## MEMO

TO: Tim Rhode, Village Administrator  
 FROM: Ryan Amtmann, Village Engineer  
 DATE: May 12, 2021  
 SUBJECT: Zion Church Redevelopment "The Church" – Rezone, Land Division and Site/Building Plan Applications

**DESCRIPTION:**  
**GRADING & DRAINAGE PLAN**

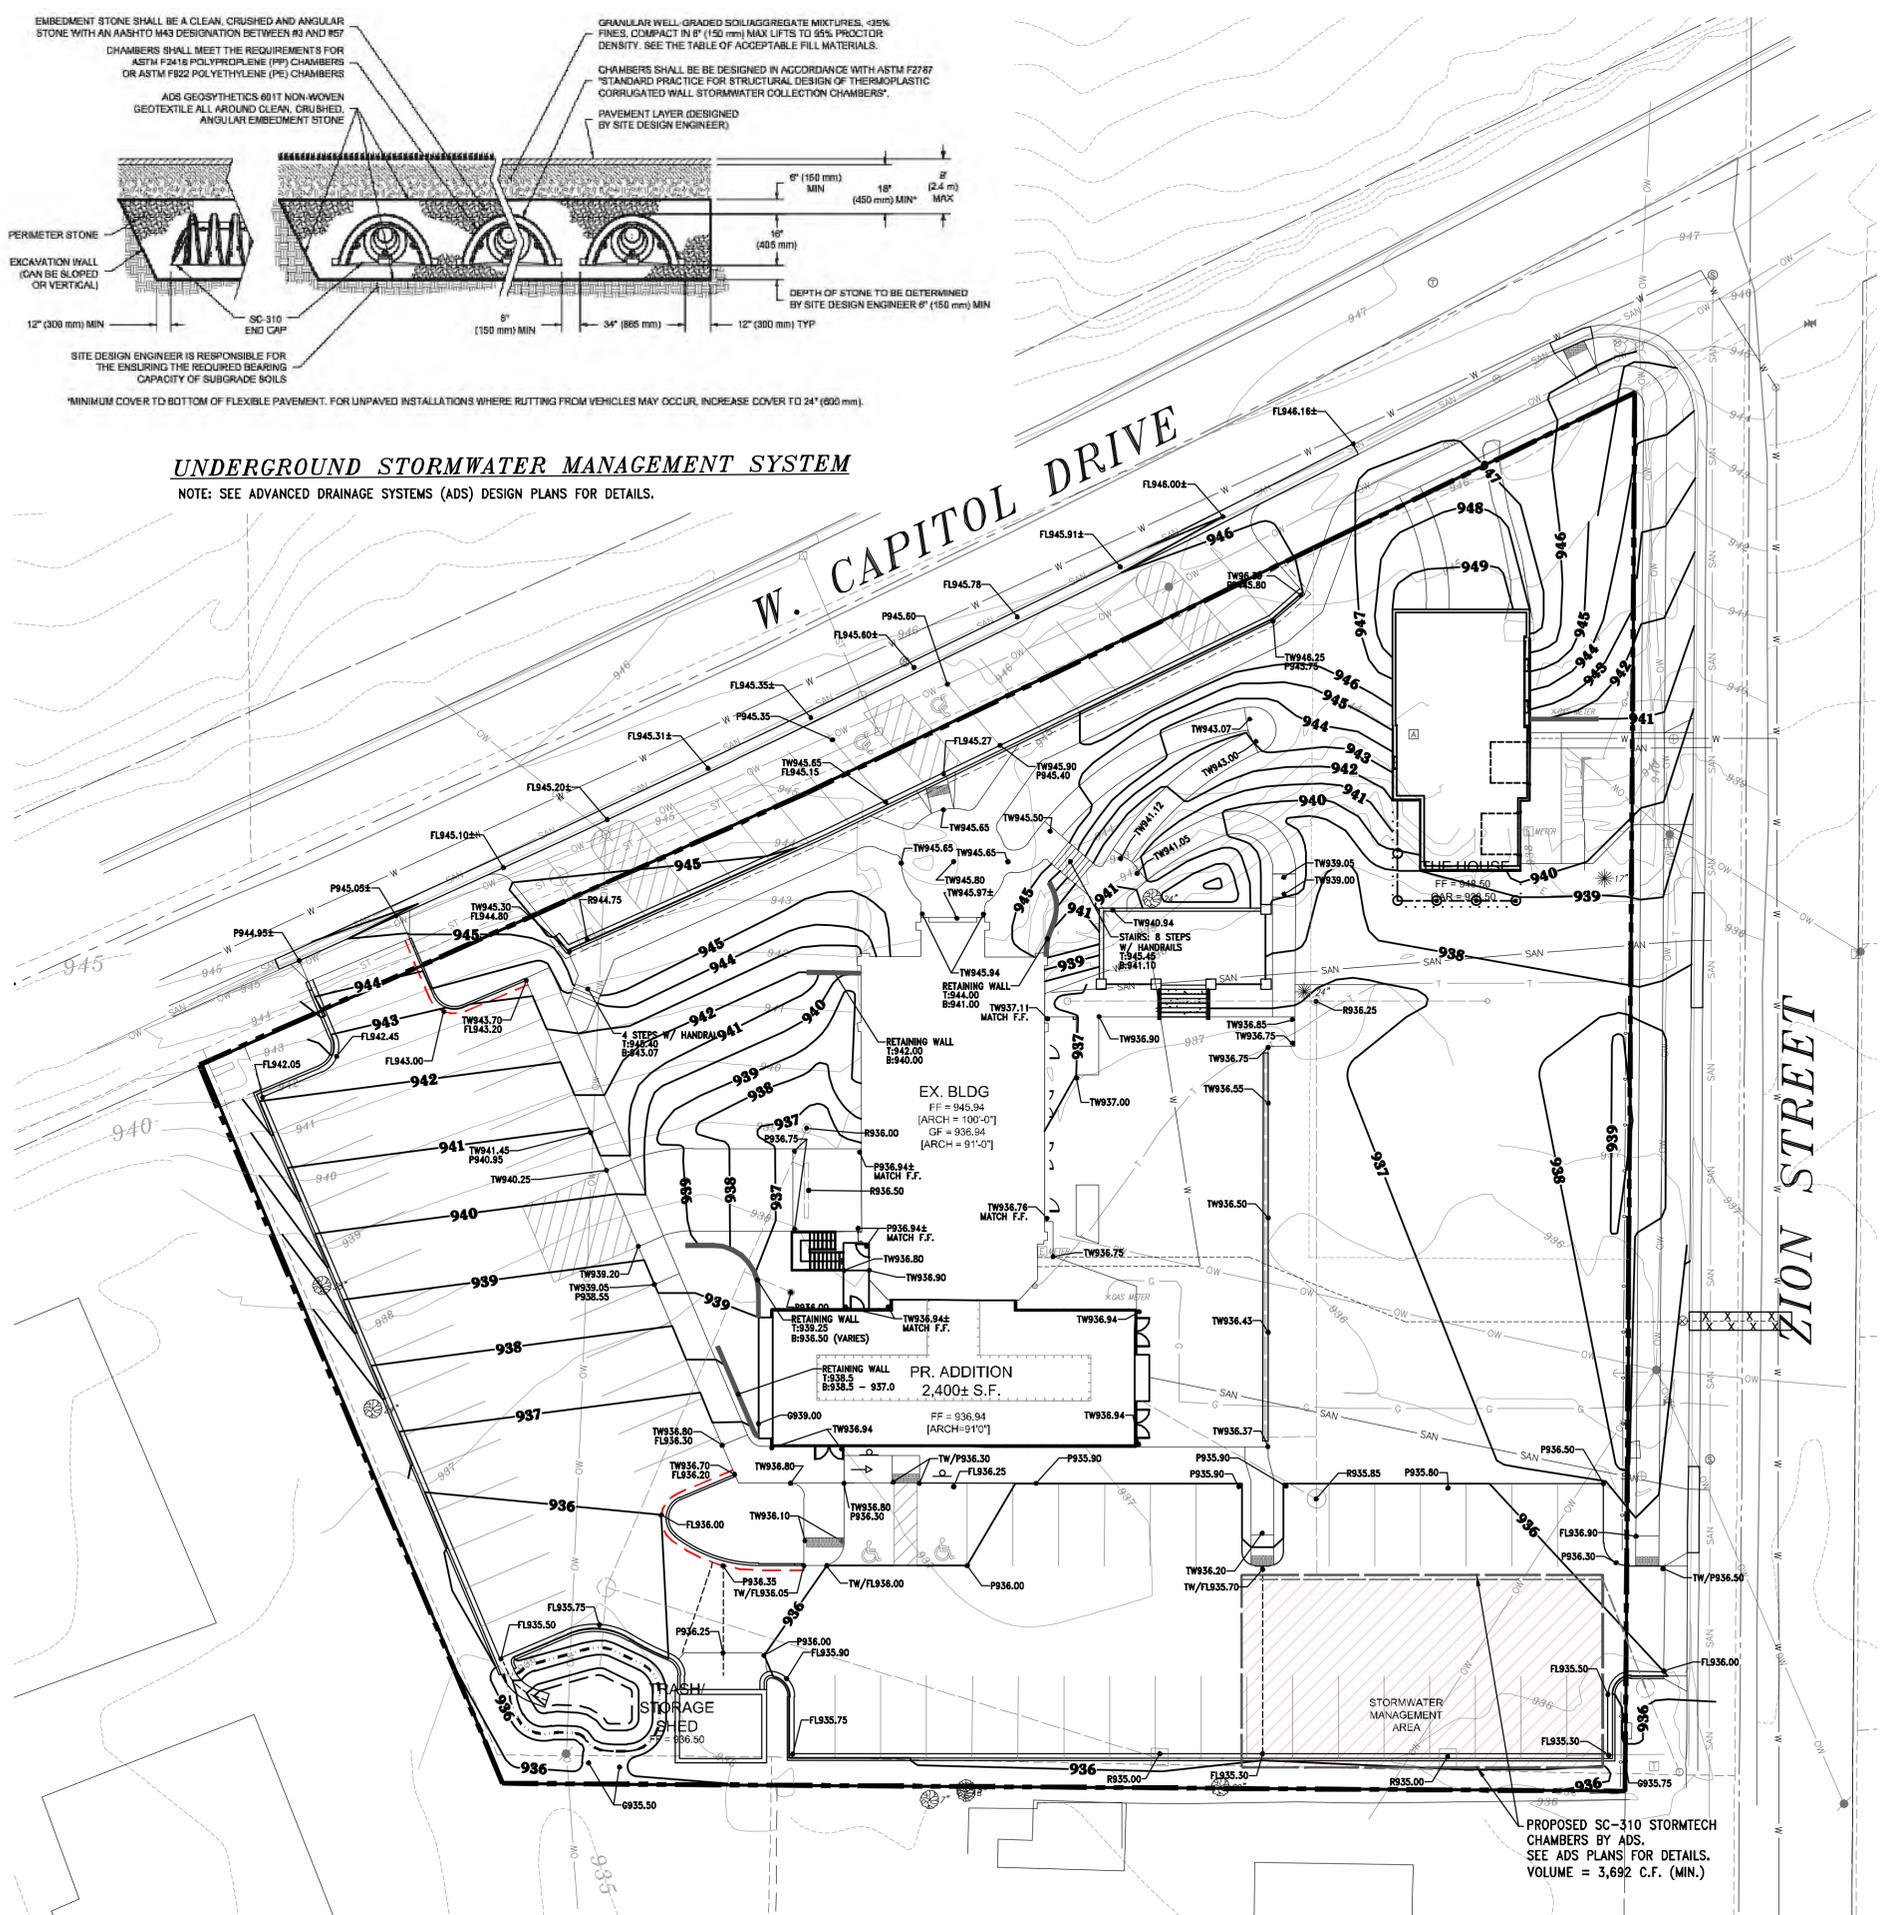
5. Sheet C1.1 and C2.0 – Applicant has modified the drainage system to include a rain garden at the south side of the westerly parking lot. It appears that the storm inlet was removed. Village Engineer thinks a rain garden is a good addition to the site, however, there needs to be storm inlet (s) in this location to collect storm water runoff from the parking lot to route the stormwater to the underground system; especially during spring/fall thawing events, when the rain garden may be filled with snow. If the rain garden remains, it should overflow into the curb/storm inlet/sewer system.

22. Plan will be reviewed and any utilities to remain will be verified.
23. A rain garden has been added to the southwest corner of the site, eliminating the need for an inlet. Refer to updated site plan. An updated Storm Water Management Plan will be provided.

**1 ARCHITECTURAL SITE PLAN**  
SCALE 1" = 20'-0"

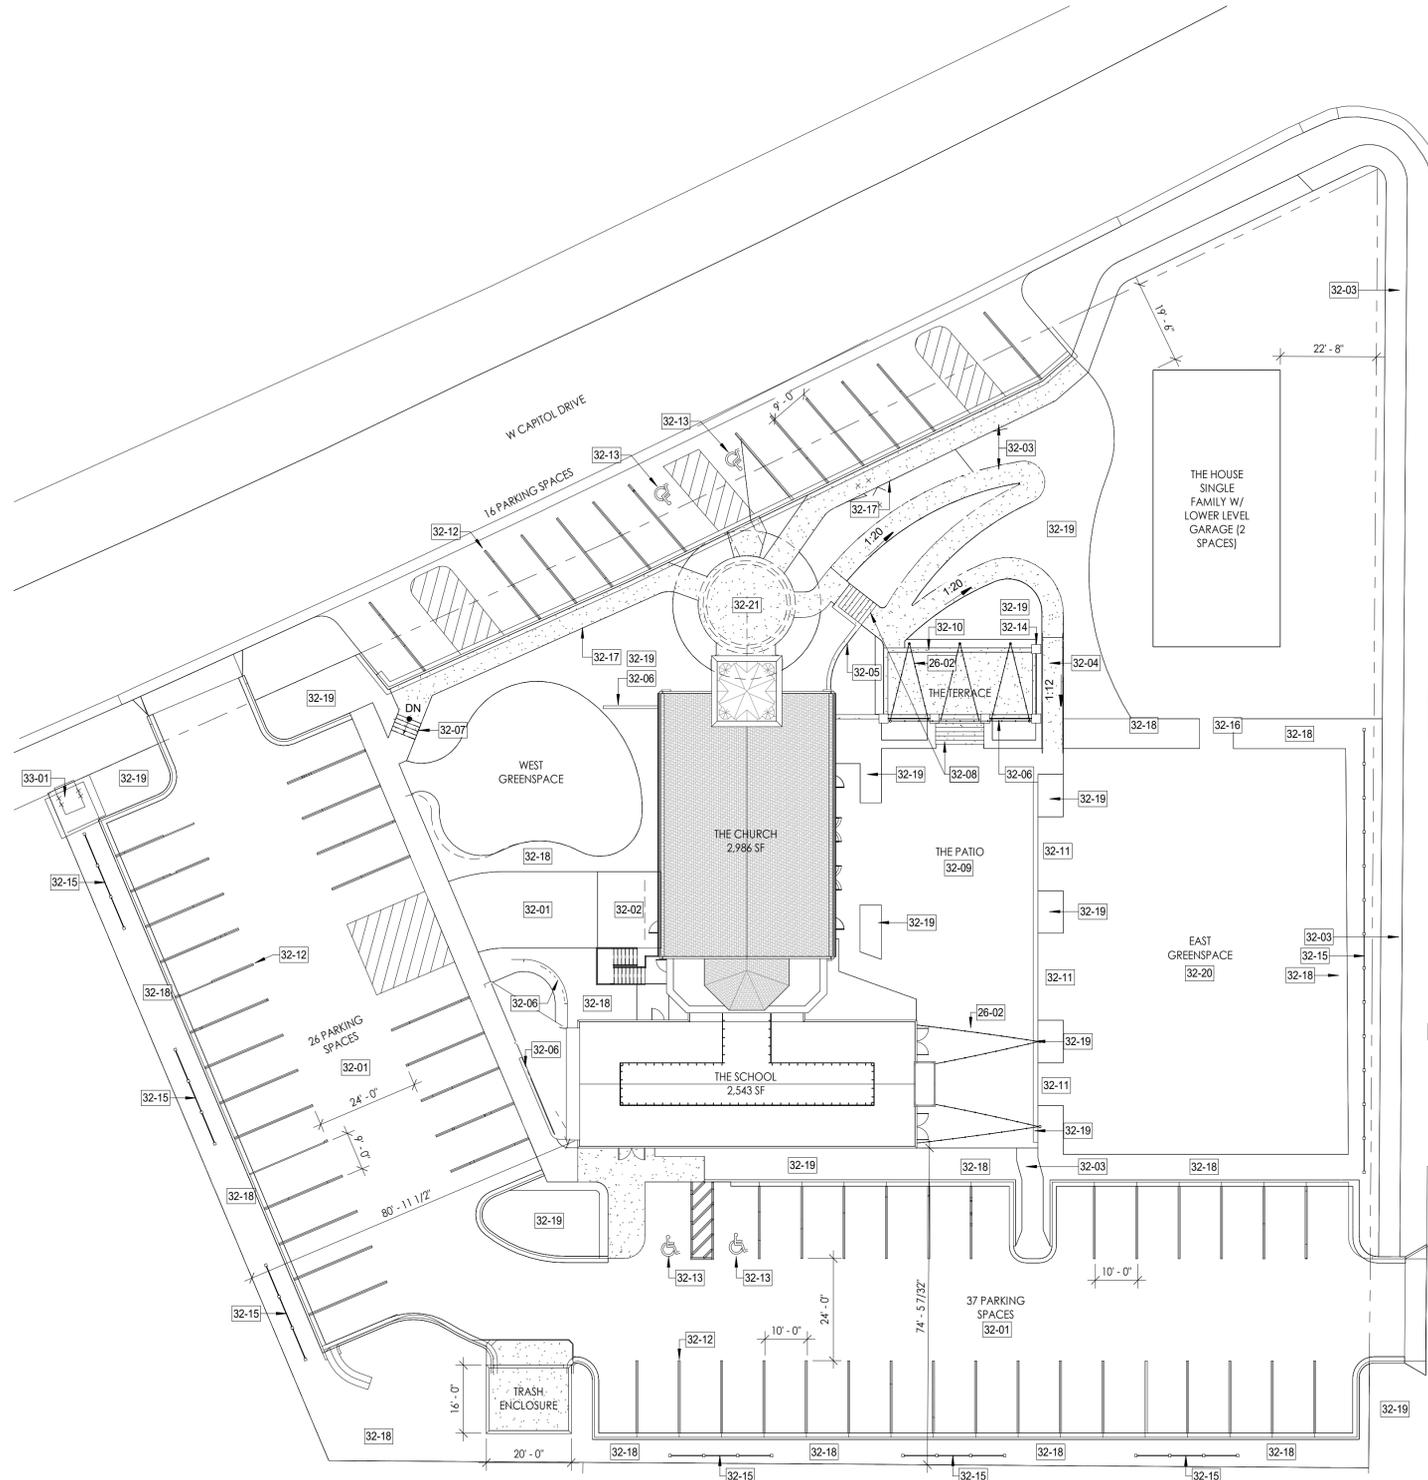
1. Sheet A050 calls out a 10-foot fence. See sheets 14 and 15 of the 21-0507 The Church Renderings so see the decorative look of the fence/landscape screen. The applicant desires to provide this substantial landscape/fence screening to isolate the guests within the venue from adjacent properties. In addition, the applicant desires this landscape screening to help dampen noise.
